Jan 2026 MDG Proposed Updates

Revision Type	Reference	Section Description (Red indicates Change of name from existing)	Description of Revision	New or Deletion	Primary POC
MDG	ALL Chapters	MANY	Editorial update throughout MDG to change "Shared Use" to "Shared-Use" to be consistent with MUTCD		Alford / Fiant
MDG	1.4	Definitions	Updated definitions for consistency with MUTCD		Alford
MDG	2.3.1.1	Planning Resources	Updated Streetlight Data Row to indicate account access provided through Office of Planning rather than Office of Roadway Engineering. Also, removed safety data available timeframe years in Walk.Bike.Ohio row.		Alford
MDG	Table 3-2	Mean Walking Speeds for Disabled Pedestrians and Users of Various Assistive Devices	Corrected walking speed for Above-knee amputee row in table		Alford
MDG	Figure 3-3	Example of Mutual Yielding Zones Illustrating Intersection Sight Distance Case A	Update figure to show current MUTCD bike symbol marking		Alford

Figure 6-21: Transitions between Offset Intersections with Two-Way Separated Bike Lanes

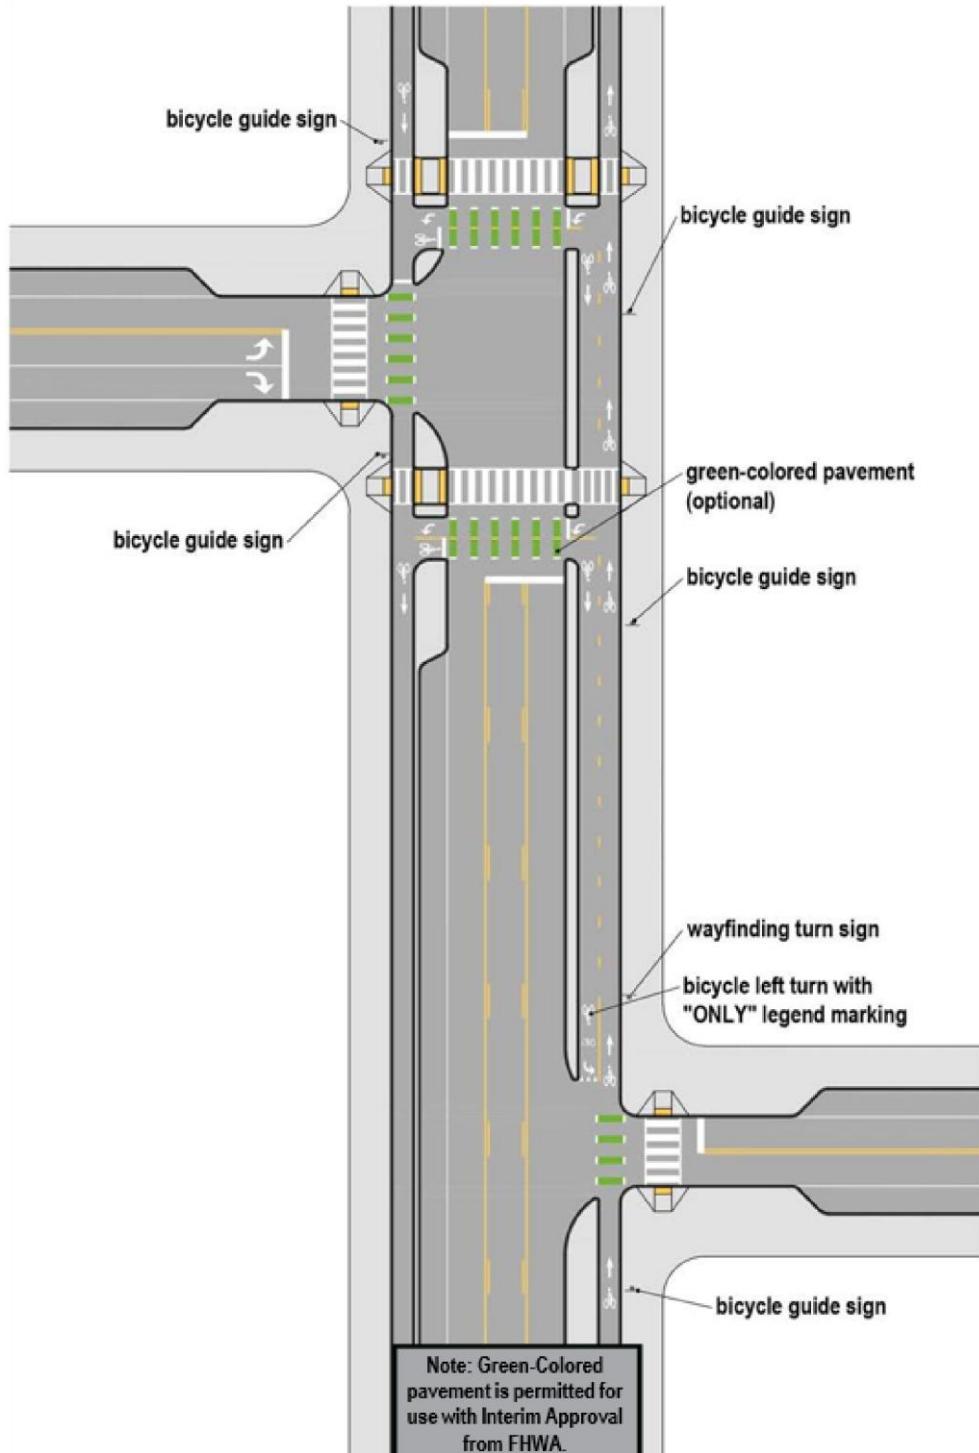
Commented [JW84R82]: TWLTL markings should not continue to intersections (Section 3B.05 P 06)

Commented [JA85R82]: Transverse markings for the sb direction would make sense there. The nb direction could be a left turn lane.

Figure 6-28: Two-Stage Left Turn Box Placement

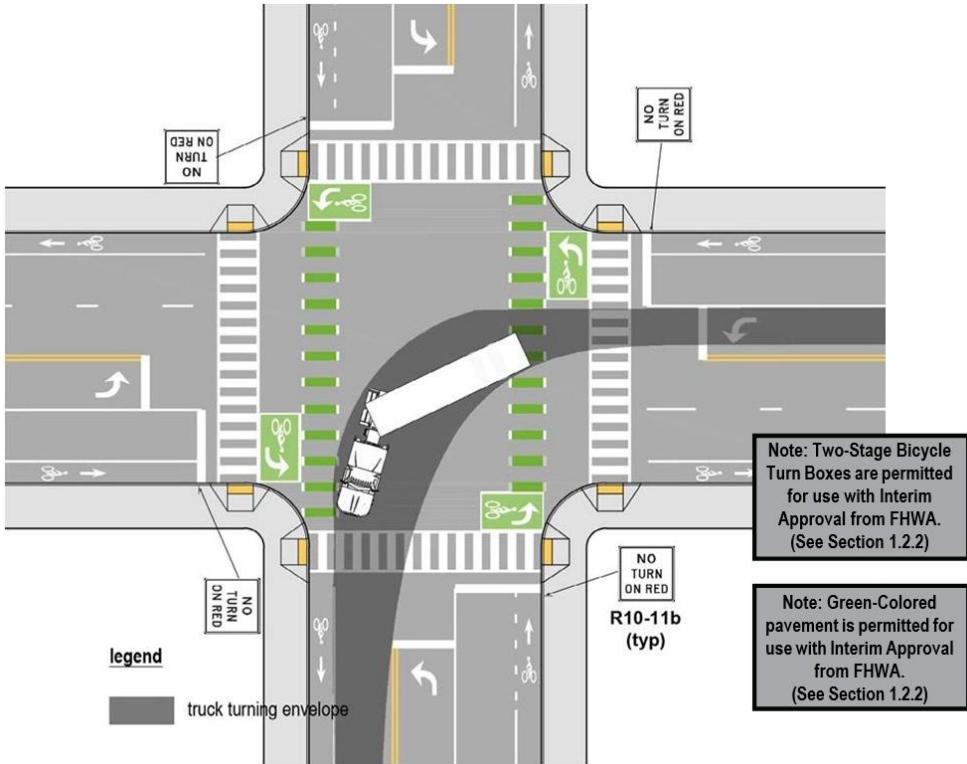
Commented [JW97]: Remove references to IA per July ORE markup.

Figure 6-29: Bicycle Box Configuration Across One Lane of Through Traffic

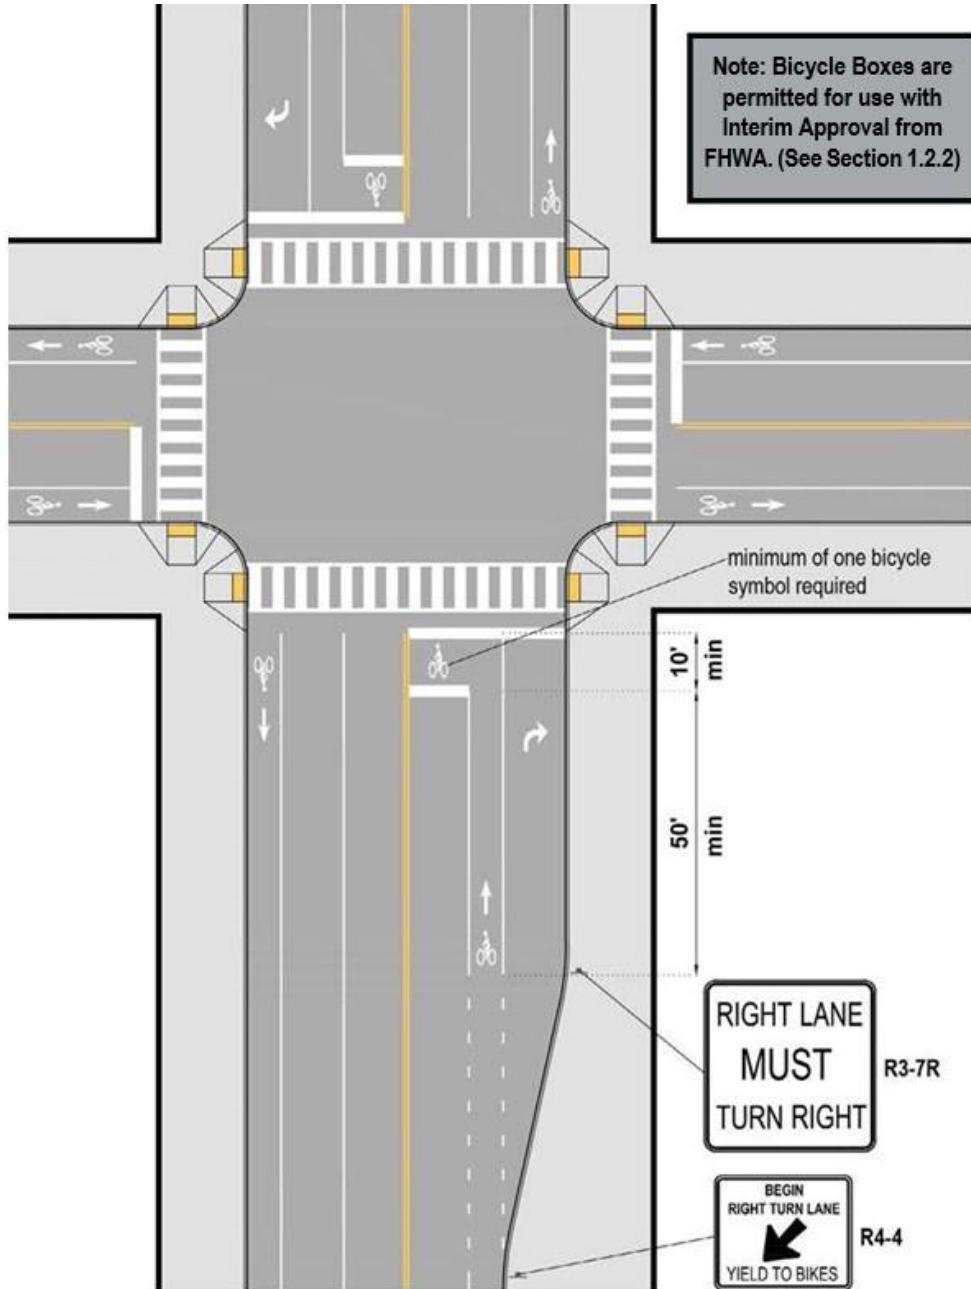
Commented [JW107R105]: Consider adding optional green paint

Commented [JA108R105]: Agree that the green paint would be a good addition that is optional

Figure 6-37: Example Bike Lanes on Streets under 35 mph with Right Turn lanes < 200 Ft. in Length

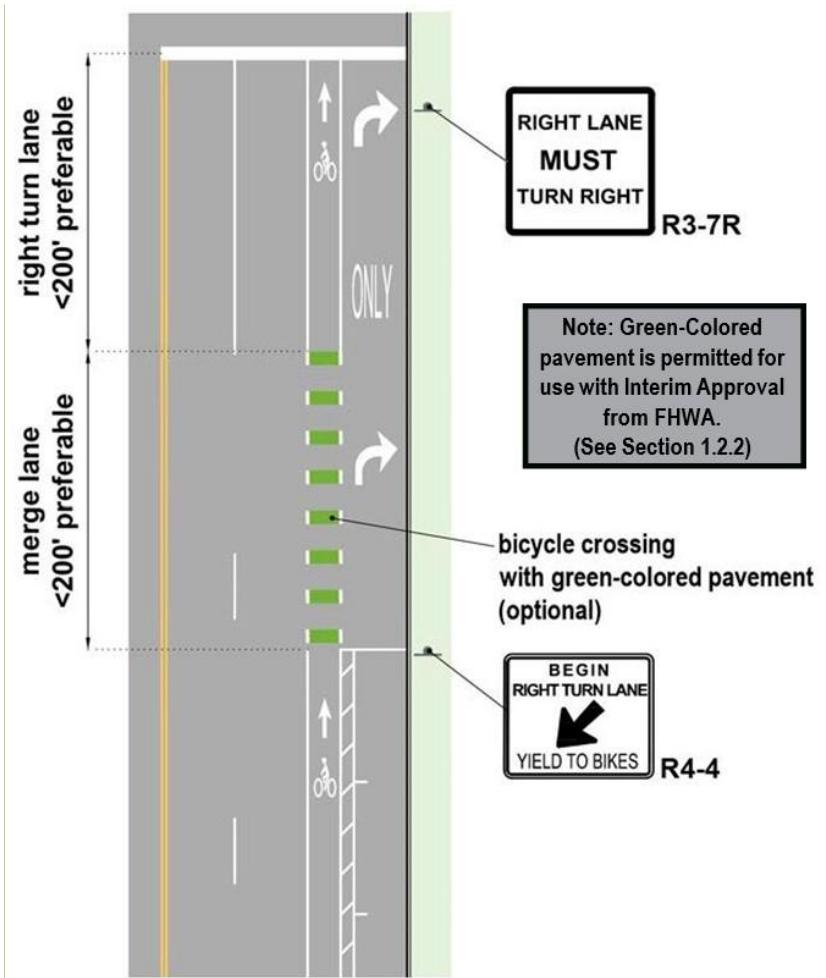
Commented [BS138]: While not conflicting MUTCD, I think the language in this section is not clear.

Figure 6-38: Example Bike Lanes on Streets over 35 mph or Right Turn Lanes > 200 ft. in Length

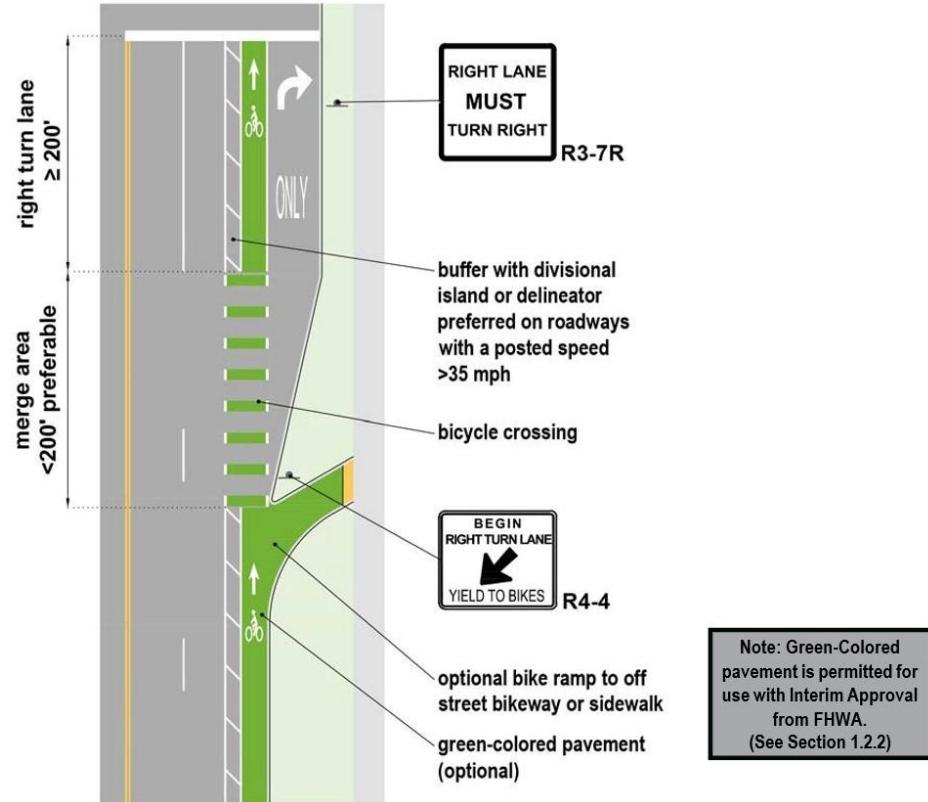
Commented [JW144]: Update graphic per July ORE markup (bike symbol still needs to be updated)

Figure 6-40: Example Right Turn Only Lane with Shared-Lane Shared-Lane Markings

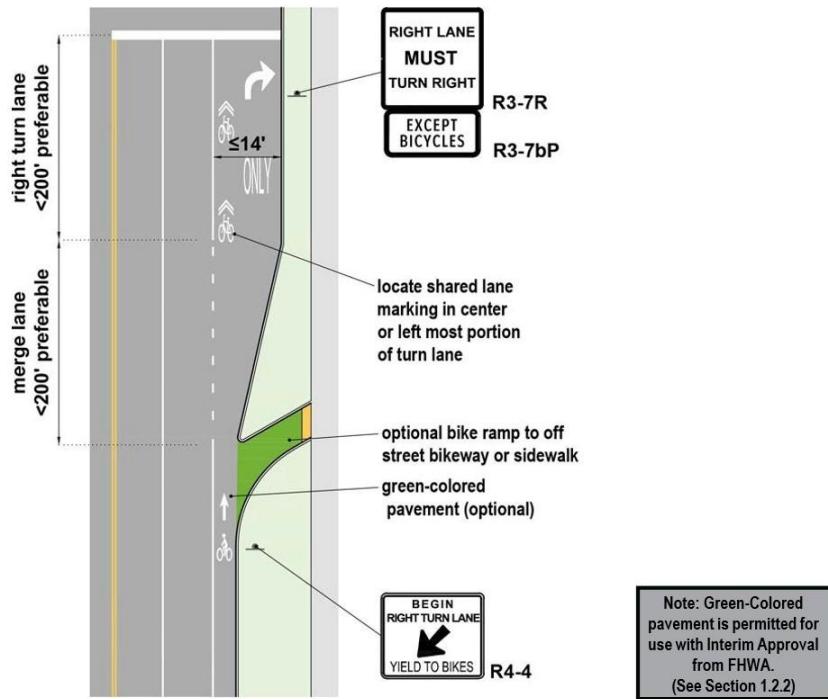
Commented [JW149]: Update graphic per July ORE markup (bike symbol still needs to be updated)

Figure 6-41: Through Lane with ~~Shared Lane~~ [Shared-Lane](#) Markings when Bike Lane Ends before Intersection

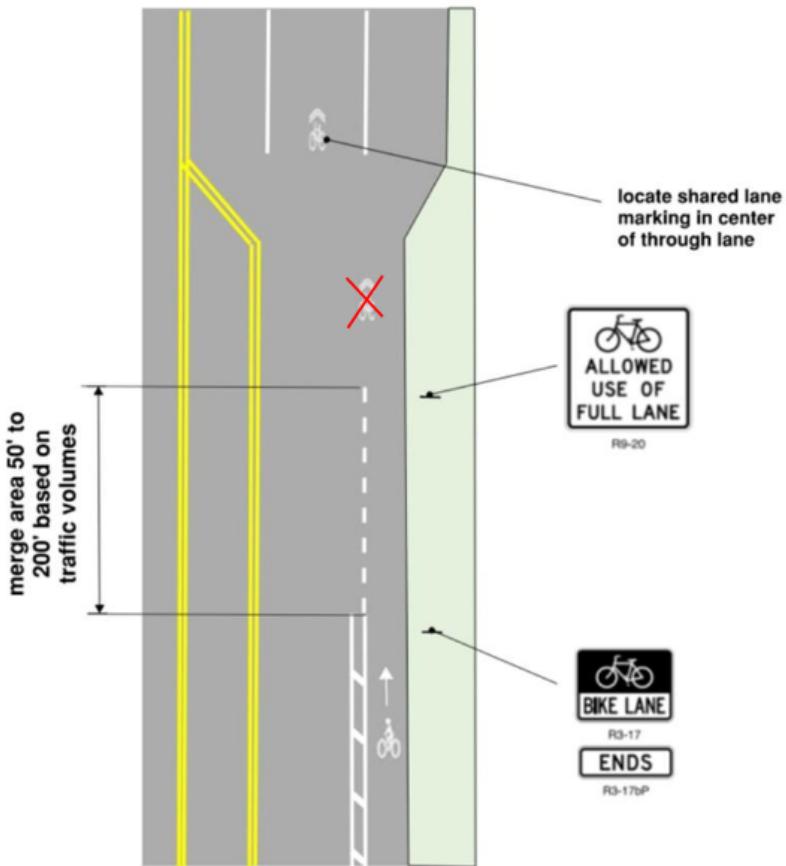
Commented [DH150]: Update bike lane marking

Figure 6-45: Example Paved Shoulder Markings to Accommodate Bicycling

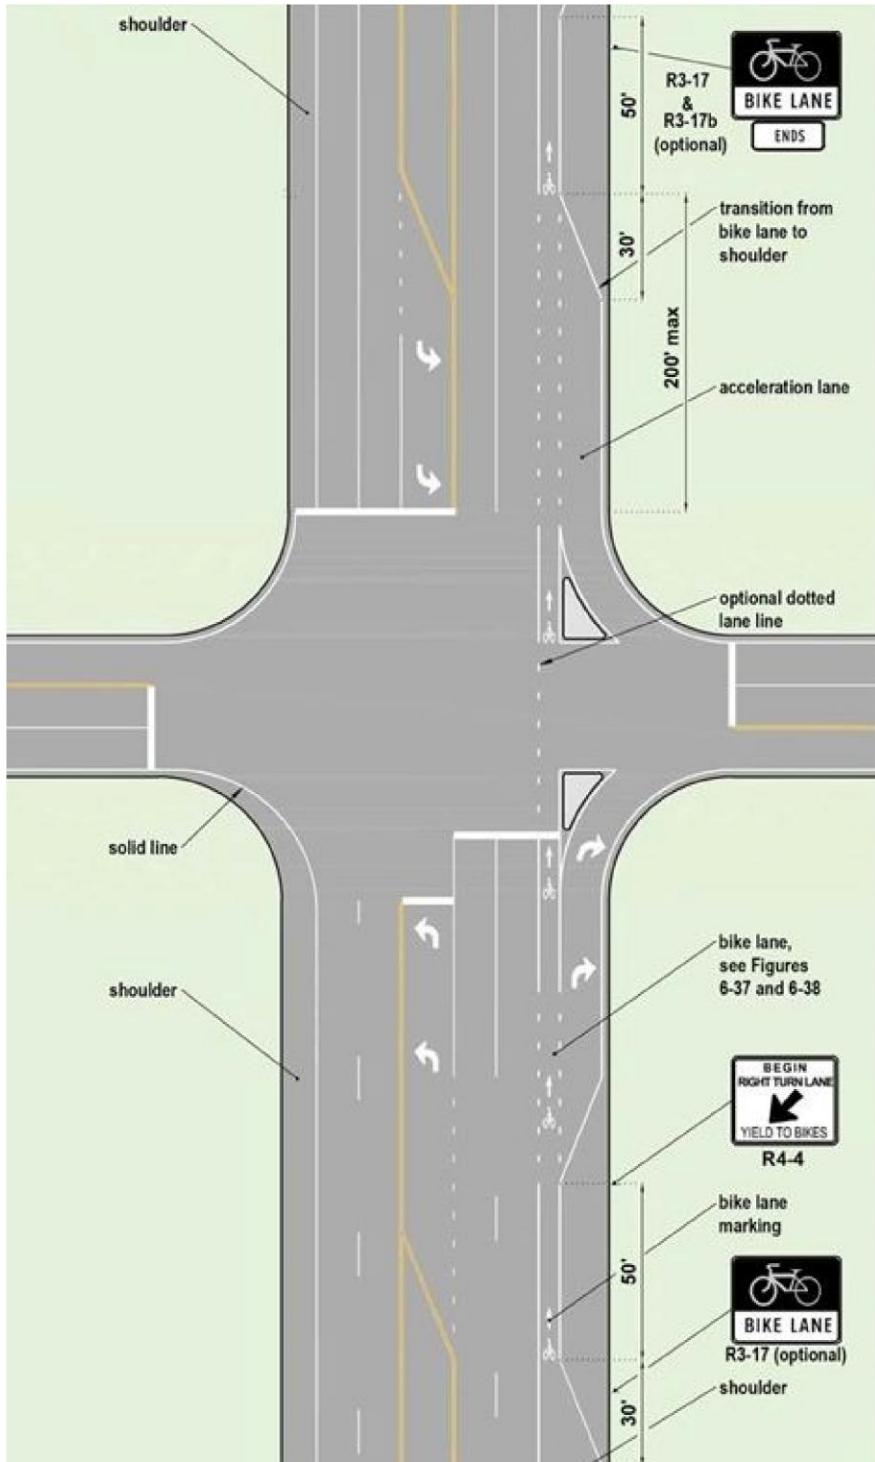
Commented [JW159]: Update bike symbols

Figure 6-46: Motorist Bypass Lane with Bicycle Lane

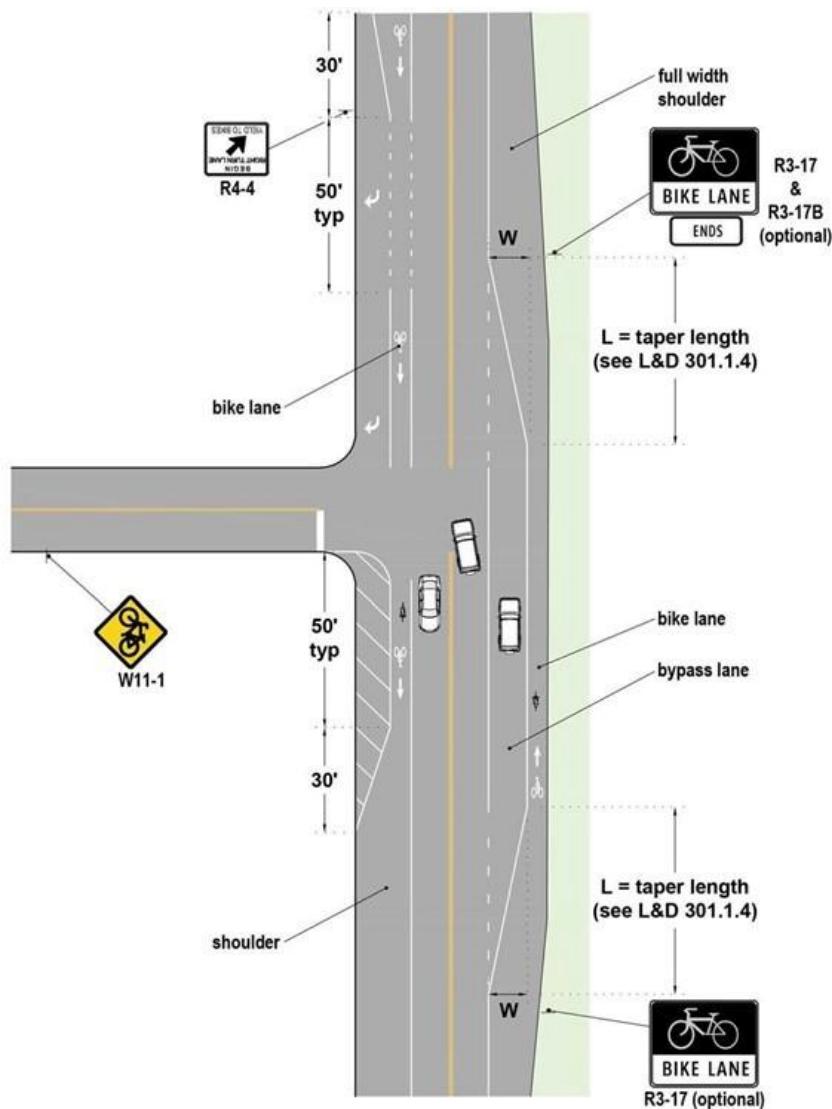
Commented [JW160]: Update bike symbols. Consider adding bike crossing markings

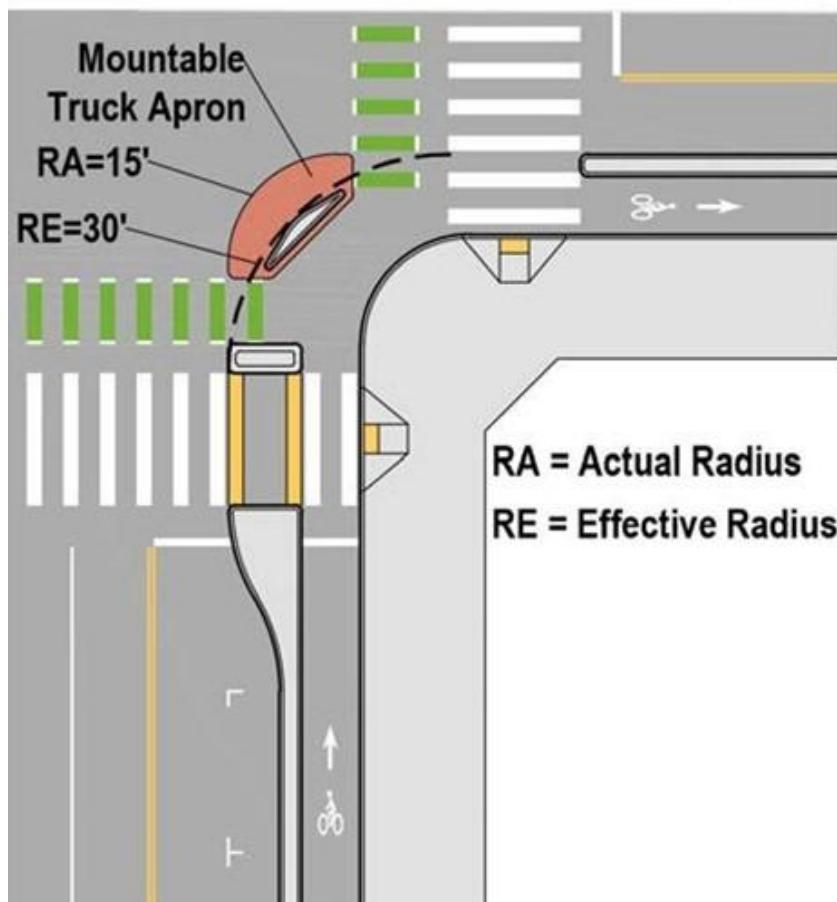
Commented [KF2]: Bike lane symbol needs to be updated per the 11th Edition of the MUTCD

Figure 7-15: Forced Turn - Directional Closure

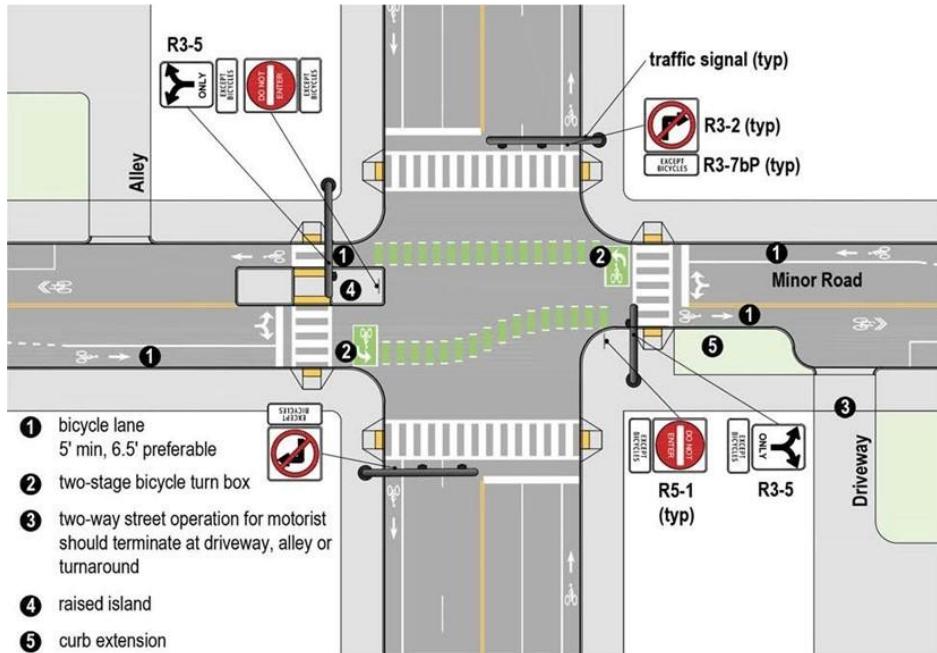
Commented [JW10]: The bicycle lane symbol marking needs to be updated per the 11th Edition of the MUTCD

Figure 7-16: Forced Turn - Right-In/Right-Out

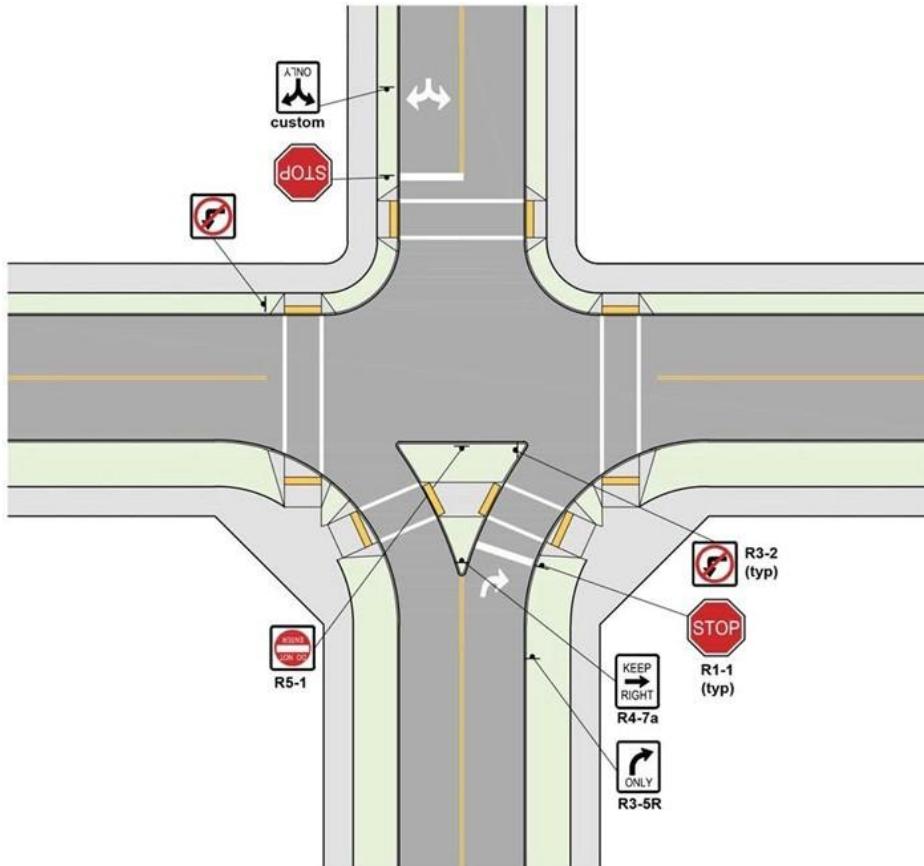
Commented [JW11]: Per MUTCD Section 2B.28 P 02, the R3-5R signs shall only be mounted overhead.
